**Re: PB2026-021; 604 Endicott St N
Jurisdiction of the Planning Board**

Re: 604 Endicott St N, Laconia Site Plan

Letter to Bob Heavey
604 Endicott St N – Stormwater Comments - Revision
June 20, 2025

Figure 1: Route 3 Flow

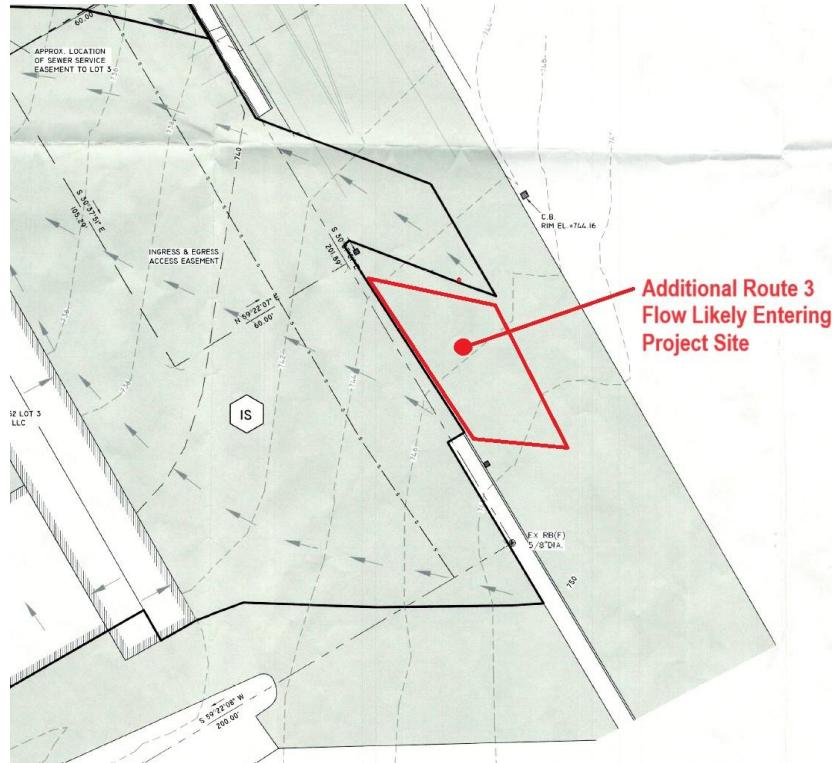
1. As stated previously, the hydrologic model appears to underestimate the area of Route 3 flowing onto 604 Endicott St N. No additional area was added to the revised stormwater calculations to account for this flow from Route 3. The existing and proposed flows onto 554 Endicott St N are likely slightly underestimated by the model. See Figure 1 and Figure 2 on the following page:

Figure 4: Rear Gravel (Pre-Condition Stormwater Map)

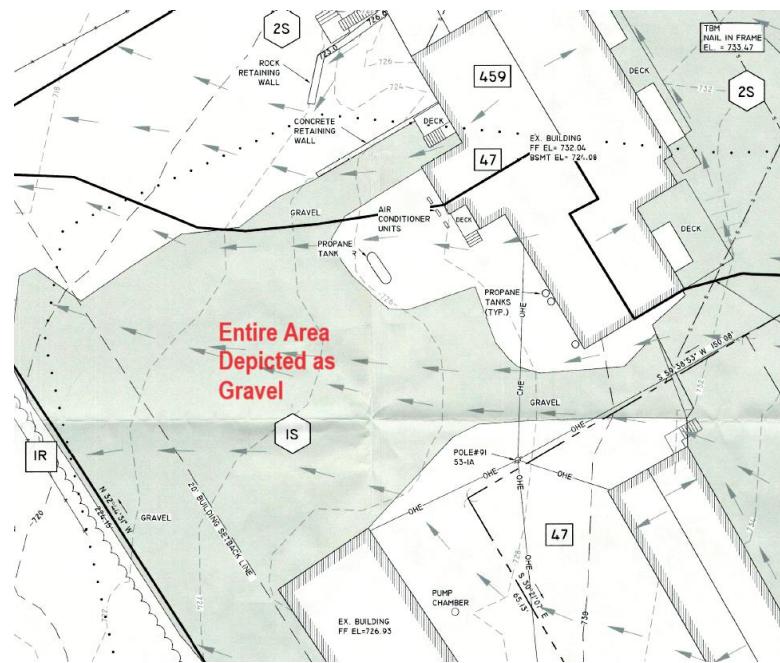
2. As stated previously, the Pre-Condition map depicts approximately 4,000 sq ft of existing gravel area that is not depicted on the Existing Conditions plan. This area was not added to the pre-development drainage model. If this gravel area does not exist then the model likely calculates the existing flows to be higher than they actually are. This, in turn, may result in proposed flows that are higher than the actual existing flows.
